# UNITED STATES PATENT AND TRADEMARK OFFICE

10/582,096

### Office Action Summary

### **DETAILED ACTION**

**FIGURE 1A**

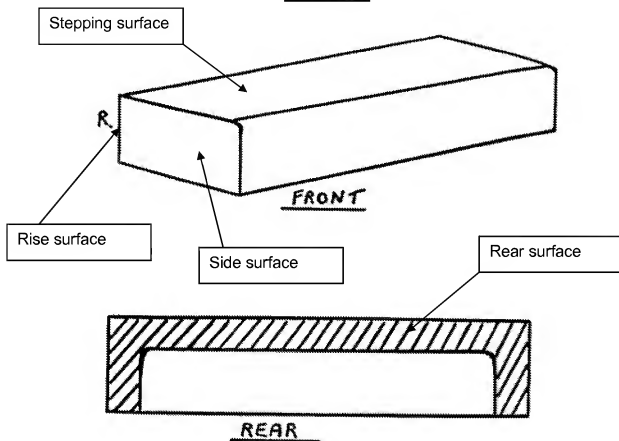
As per claim 1, Millar teaches a pre-cast concrete block for constructing a staircase (precast reinforced concrete step; abstract), comprising a horizontal stepping surface (as illustrated, the step has a horizontal stepping surface; figure 1A below), a

rise surface perpendicular to the stepping surface (as illustrated, the step has a rise surface which is perpendicular to the stepping surface; figure 1A below), and a rear surface (as illustrated, the step has a rear surface; figure 1A below); the rear surface having a recess for reducing the weight of the block (as illustrated, the rear surface is hollowed out; figure 1A below; this will reduce the weight of the step), the recess having round parts, with a specified radius at inner corner parts of the recess (as illustrated, the step has rounded surfaces at the inner corner parts; figure 1A below).

In addition, Millar discloses side surfaces (figure 1A below), but fails to disclose displacement prevention grooves in respective side surfaces of the block.
